## Trunk road A82: the Loch Lomondside road: conception to implementation

## DISCUSSION

*Fig. 12. Bulk blasting: A90 rock cutting north of Forth Bridge*

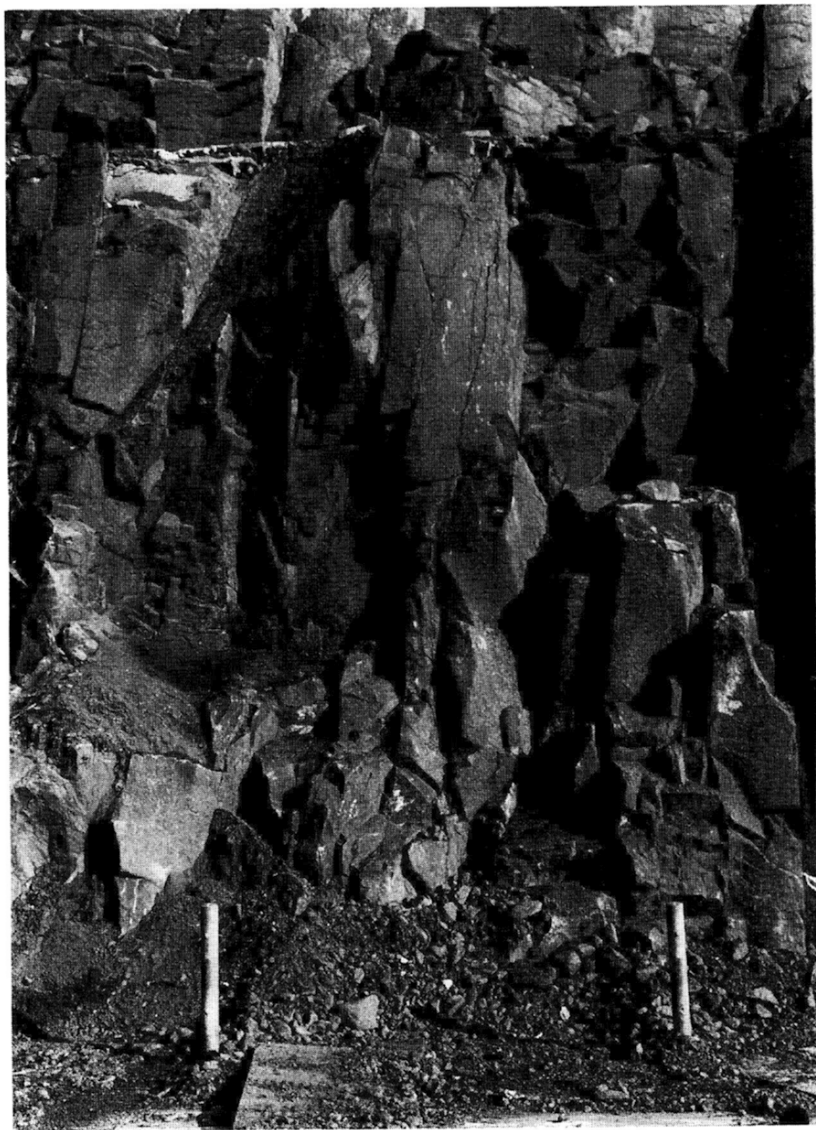
72. A striking example of the type of cutting produced by bulk blasting alone is the cutting, in dolerite, to the north of the Forth Road Bridge on the A90. As can be seen in Fig. 12, this has left the sides of the cutting in a fractured and loosened state which has required considerable and continuing maintenance over the years.

*Fig. 13. Presplit blasting: M90 at Moncrieffe Hill*

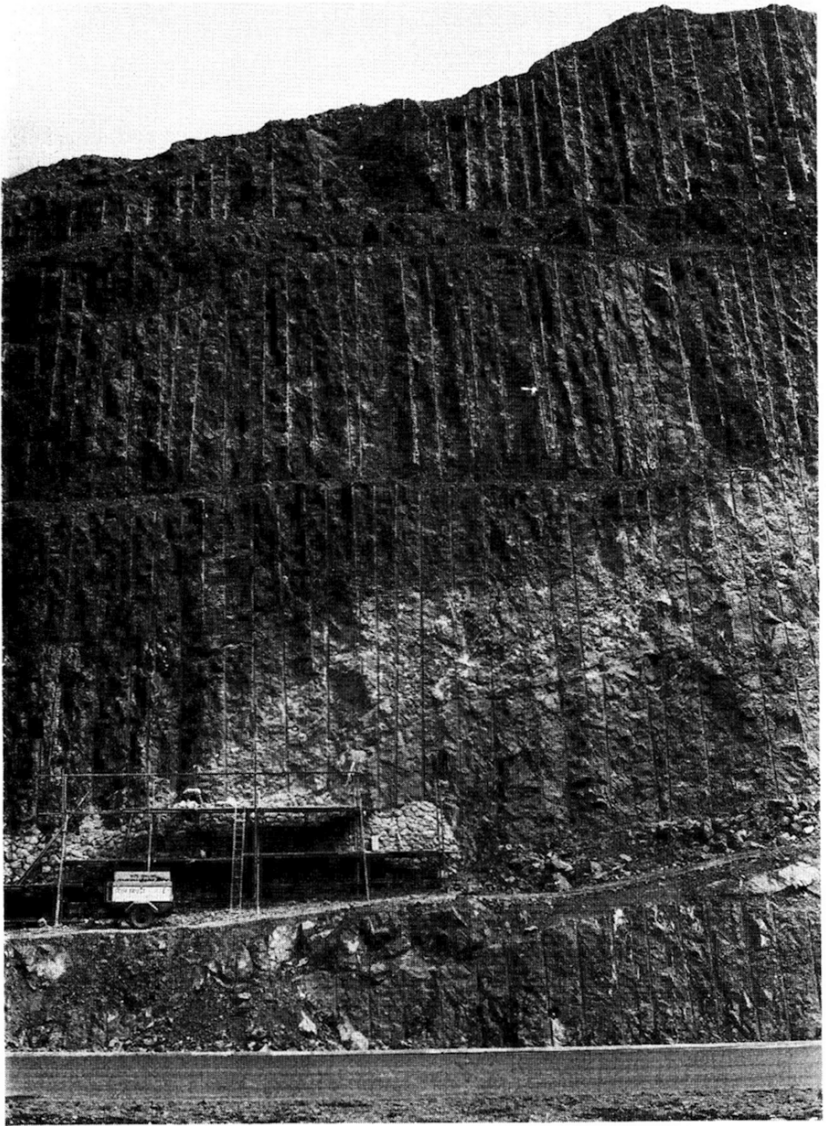
73. On the other hand, the cutting on the M90 at Moncrieffe Hill (Fig. 13), where Babbie, Shaw and Morton were again the consulting engineers, shows how presplit blasting produces an excellent final face. As can be seen, there are two basaltic lava flows, and while presplitting has dealt effectively with the rock faces themselves, masonry is being placed to protect the easily weathered pyroclastic material between the flows.
